ELEM DIAG — NUCLEAR BOILER PROCESS INSTR SYS — FIRST MADE FOR 238X178AF

STONE & WEBSTER ENGINEERING CORPORATION
NINE MILE POINT NUCLEAR STATION - UNIT 2
NIAGARA MOHAWK POWER CORPORATION
J. O. 12177

✓ INSTRUCTIONS TO SUPPLIER (E2): Comments As Noted
- APPROVED
- APPROVED AS REVISED (AS DEFINED IN SPECIFICATION)
- RELEASED FOR FABRICATION
- RELEASED FOR MATERIAL PURCHASE
- SUPPLIER TO RESUBMIT — QNTY: REVISED PRINTS; REVISED MICROFILM APERTURE CARDS; FOR REVIEW; FOR RECORD; NONE REQUIRED

MFR'S DWG NO (C)(LIMIT TO 24 CHARACTERS & BLANKS)(37-60): 807E153TY Sh.1 Rev3
MFR'S NAME (C)(LIMIT TO 20 CHARACTERS & BLANKS)(61-80): General Elect

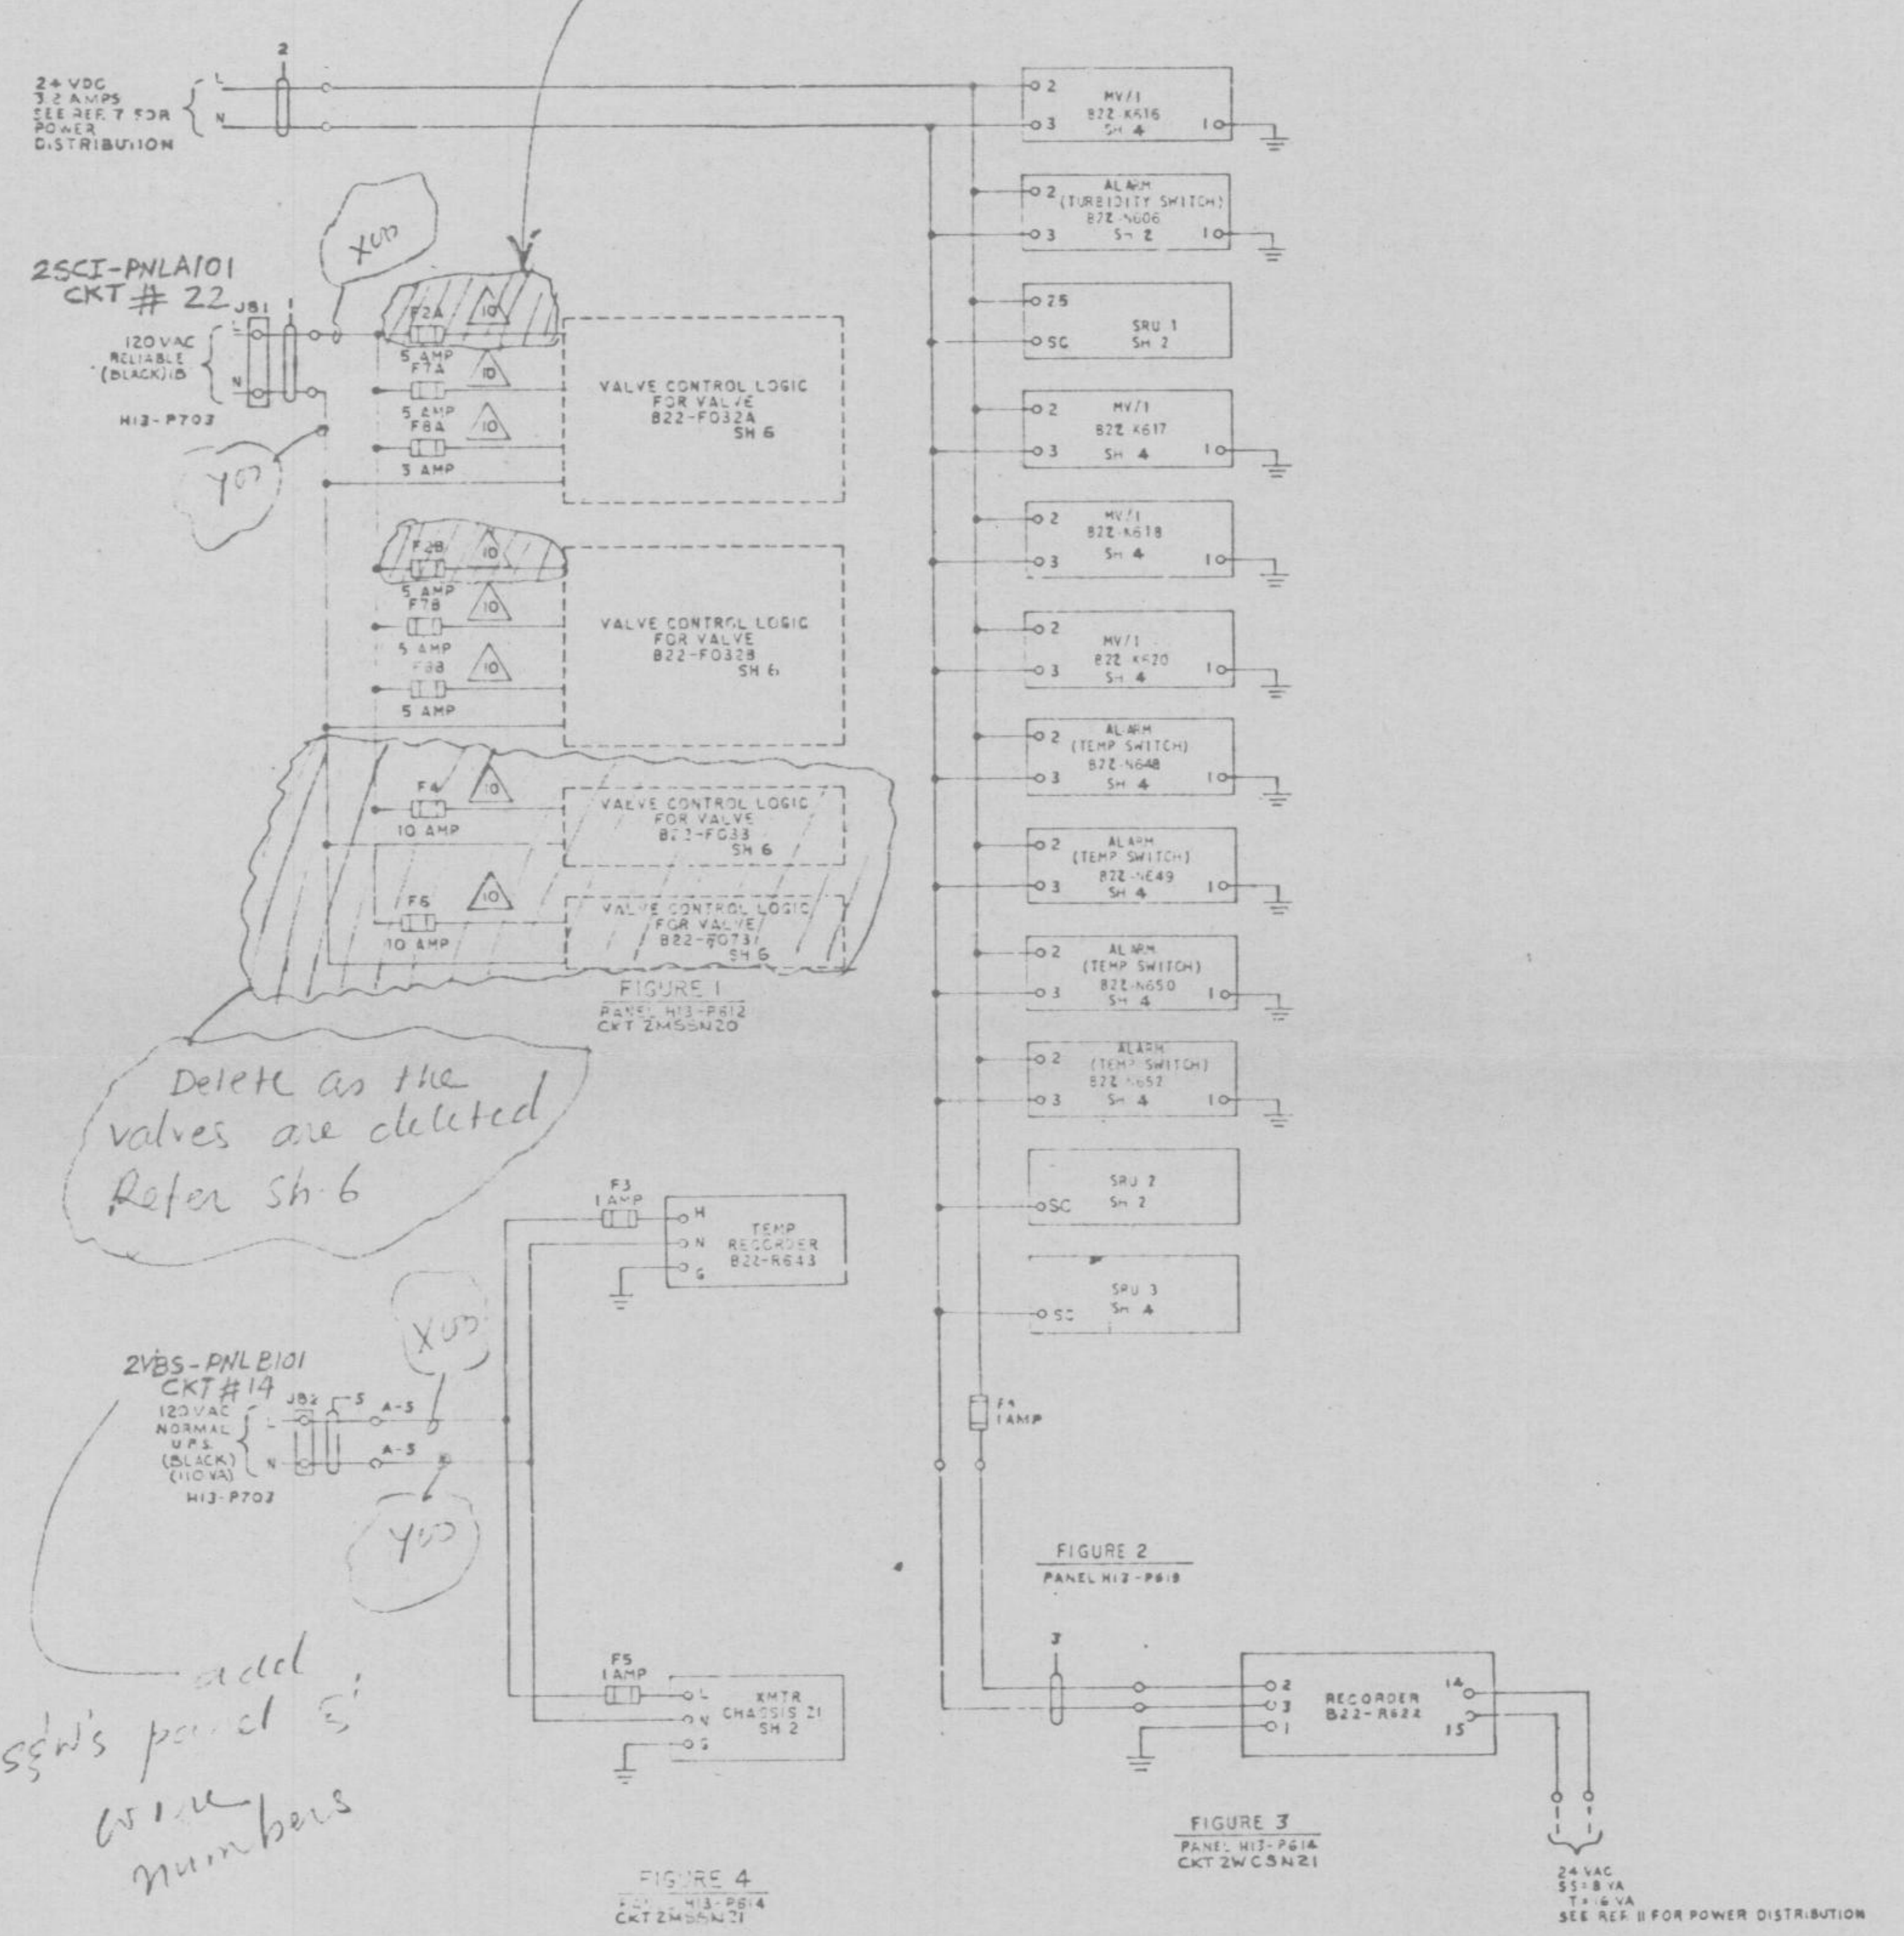
Refer control circuit on Sh #6, this fuse is not required in the circuit.

Delete as the valves are deleted Refer Sh 6

add S&W's panel & wire numbers

Table 1 shows only 7 T/C, please revise the note (7)

Second element of T/C G33-N021 is directly wired to selector switch on pnl 602. See Ref 7, Sh 4

As per GE letter NMP2-1893 dated 7/11/77, indicate power supply requirement → 120-Vac supply is required
